U.S. Department  
of Transportation  
**Federal Highway  
Administration**

In Reply Refer To:  
HSA-10/SS-137

Thank you for your April 4 letter requesting the Federal Highway Administration's (FHWA) acceptance of your company's Decorative Sign Supports as breakaway systems for use on the National Highway System (NHS). Accompanying your letter was a report from the Texas Transportation Institute and videos of the crash tests. You requested that we find five of these supports acceptable for use on the NHS under the provisions of the National Cooperative Highway Research Program (NCHRP) Report 350 "Recommended Procedures for the Safety Performance Evaluation of Highway Features."

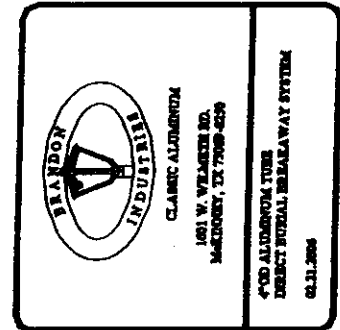
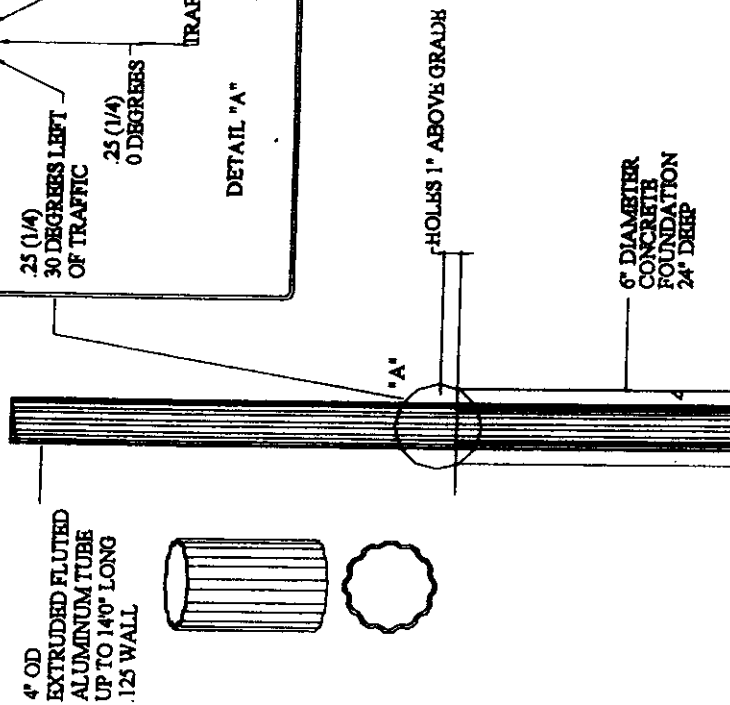
#### P1 (This system is not acceptable unless successfully tested at 100 km/hr)

This support was a 3.0-inch O.D. extruded fluted aluminum tube with a 0.125-inch wall. Two 0.06125-inch diameter holes were drilled, each at 60 degrees from the impact face and placed 1.0 inch above the top of a precast 6-inch diameter, 24-inch deep footing. One 24-inch diameter framed STOP sign and two cast aluminum street signs were mounted at 10 feet and 11 feet respectively above the ground. The pole and cap weighed 21 pounds and the signs weighed a total of 30 pounds.

\* The results of test P1 are at the limit of acceptability. NCHRP Report 350 requires that breakaway supports be qualified at both 35 km/hr and 100 km/hr. Through experience we know that the 35 km/hr results for tests P2 through P5 indicate that the 100 km/hr test is very likely to be acceptable. We do not have that same certainty for the marginal results of Test P1.

Figure C3. Details of the decorative sign post used in test DES P2.

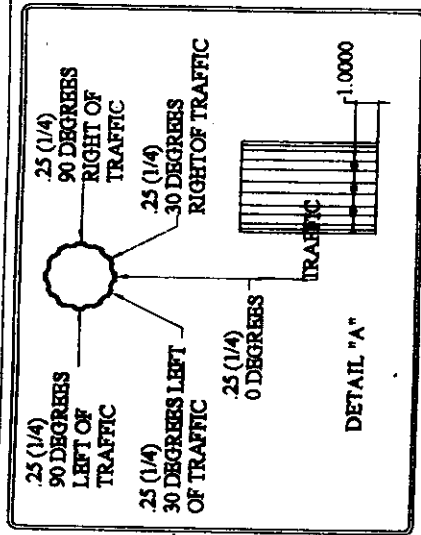
P2 ( Systems P2 through P5 are acceptable for use)

This support was a 4.0-inch O.D. extruded fluted aluminum tube with a 0.125-inch wall. Four 0.25-inch diameter holes were drilled, at 30 degrees and 60 degrees from the impact face and placed 1.0 inch above the top of a precast 6-inch diameter, 24-inch deep footing. One 24-inch diameter framed STOP sign and two cast aluminum street signs were mounted at 10 feet and 11 feet respectively above the ground. The pole and cap weighed 21 pounds and the signs weighed a total of 30 pounds.

Velocity changes were all within acceptable limits for tests P2 through P5, and the only stubs remaining were less than 4 inches or were not substantial. The results of testing met the FHWA requirements and, therefore, the devices described and tested as P2, P3, P4, and P5 above and shown in the enclosed drawings for reference are acceptable for use as Test Level 3 devices on the NHS under the range of conditions tested, when proposed by a State.

Figure C4. Details of decorative post used in test DES P3.

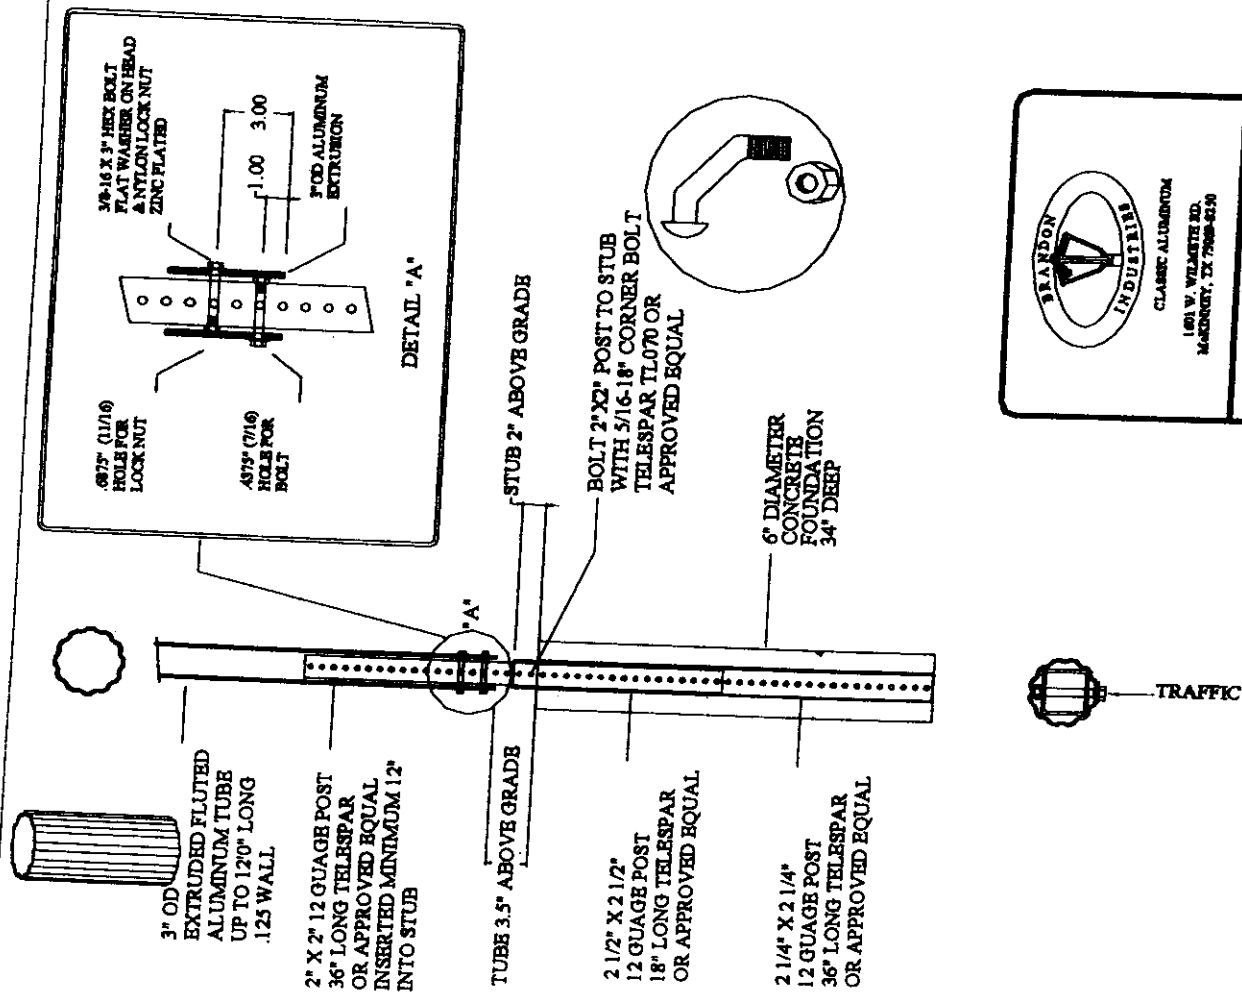
P3

This support was a 3.0-inch O.D. extruded fluted aluminum tube with a 0.125-inch wall. The tube was attached to a 2.0 x 2.0 x 12 ga. perforated square steel tube (PSST) with 0.075-in x 3.0-in hex head bolts. The PSST extended 14.25-in up into the aluminum tube. A 2.25 x 2.25 x 36-in long 12 ga. PSST extended to the bottom of a precast 6-inch diameter, 34-inch deep concrete footing. The top 18 inches was sleeved with a 2.5 x 2.5 x 12 ga PSST. One 24-inch diameter framed STOP sign and two cast aluminum street signs were mounted at 10 feet and 11 feet respectively above the ground. The pole, cap, and PSST weighed 23 pounds and the signs weighed a total of 30 pounds.

Figure C5. Details of decorative post used in test DES P4.

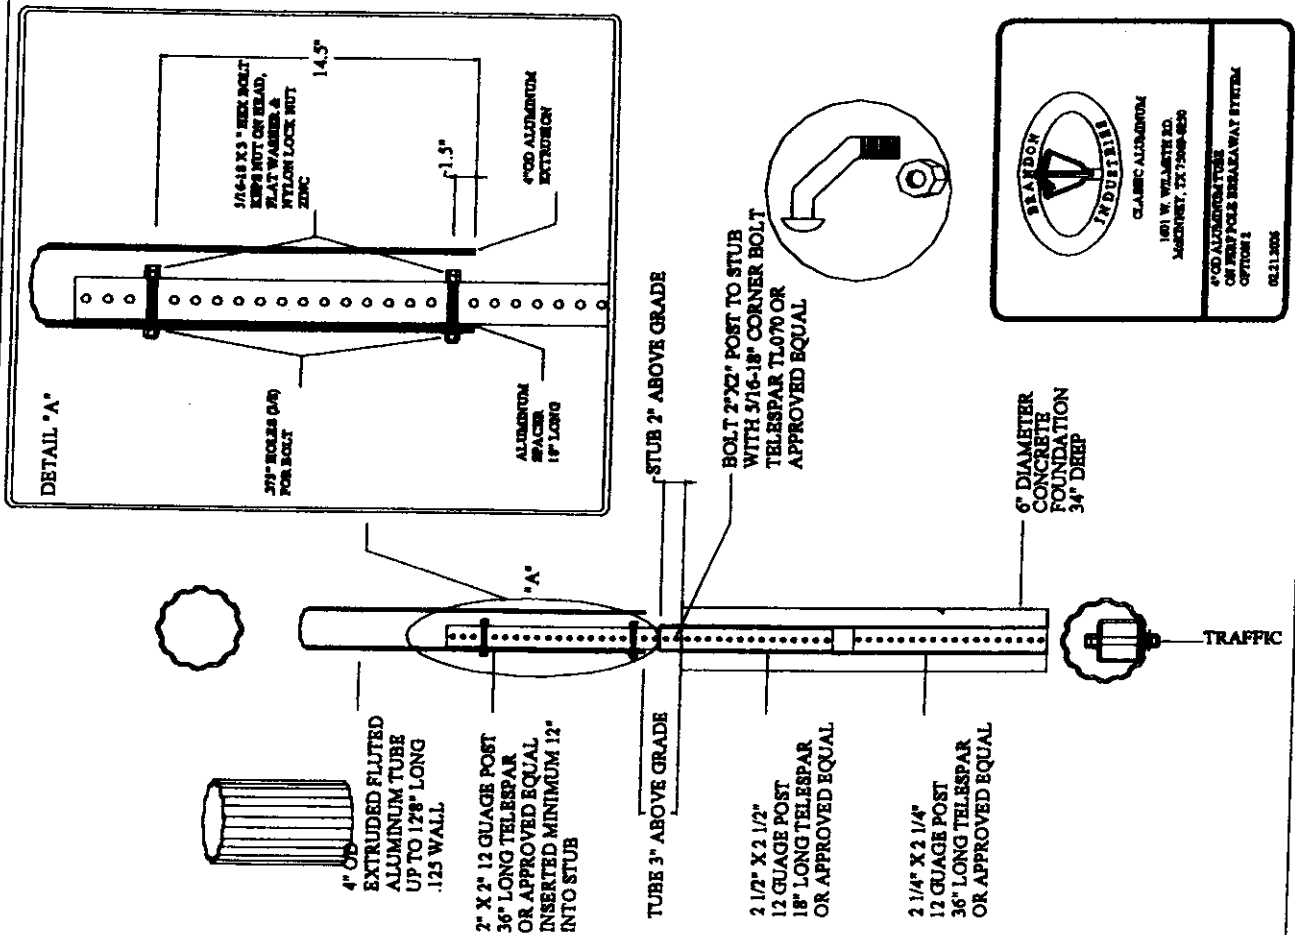
P4

This support was a 4.0-inch O.D. extruded fluted aluminum tube with a 0.125-inch wall. The tube was attached to a 2.0 x 2.0 x 12 ga. PSST with 0.075-in x 3.0-in hex head bolts. The PSST extended 12-in up into the aluminum tube. A 2.25 x 2.25 x 36-in long 12 ga. PSST extended to the bottom of a precast 6-inch diameter, 34-inch deep concrete footing. The top 18 inches was sleeved with a 2.5 x 2.5 x 12 ga PSST. One 24-inch diameter framed STOP sign and two cast aluminum street signs were mounted at 10 feet and 11 feet respectively above the ground. The pole, cap, and PSST weighed 25 pounds and the signs weighed a total of 30 pounds.

Figure C6. Details of decorative post used in test DES P5.

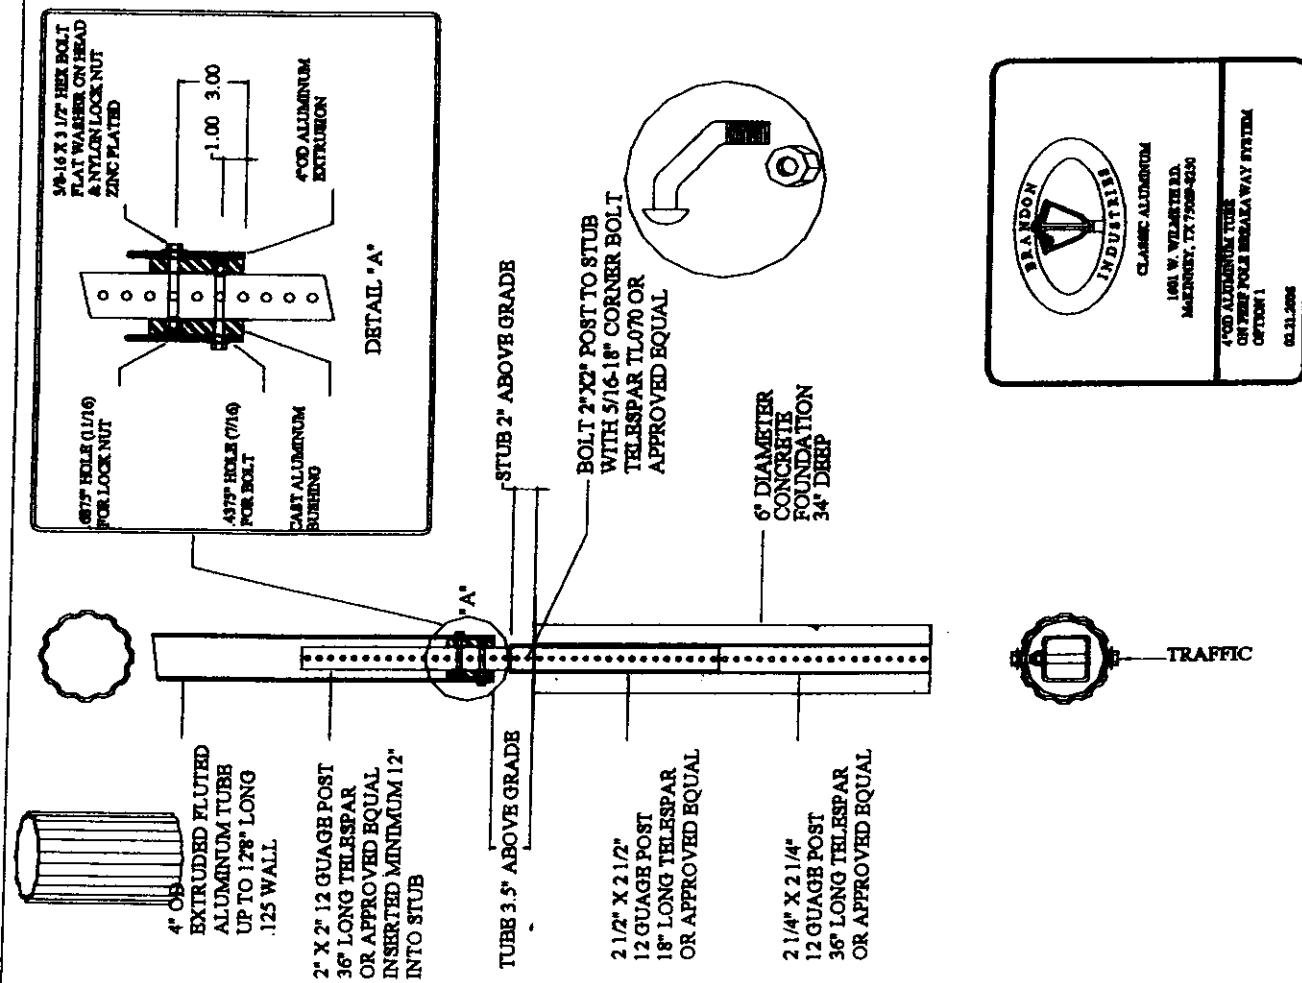
P5

This support was a 4.0-inch O.D. extruded fluted aluminum tube with a 0.125-inch wall. The tube was attached to a 2.0 x 2.0 x 12 ga. PSST with 0.075-in x 3.0-in hex head bolts. A cast aluminum bushing was placed between the PSST and the inside of the aluminum tube. The PSST extended 14.25-in up into the aluminum tube. A 2.25 x 2.25 x 36-in long 12 ga. PSST tube extended to the bottom of a precast 6-inch diameter, 34-inch deep footing. The top 18 inches was sleeved with a 2.5 x 2.5 x 12 ga PSST. One 30-inch diameter framed STOP sign and two cast aluminum street signs were mounted at 11 feet and 12 feet respectively above the ground. The pole, cap, and PSST weighed 23 pounds and the signs weighed a total of 39 pounds.
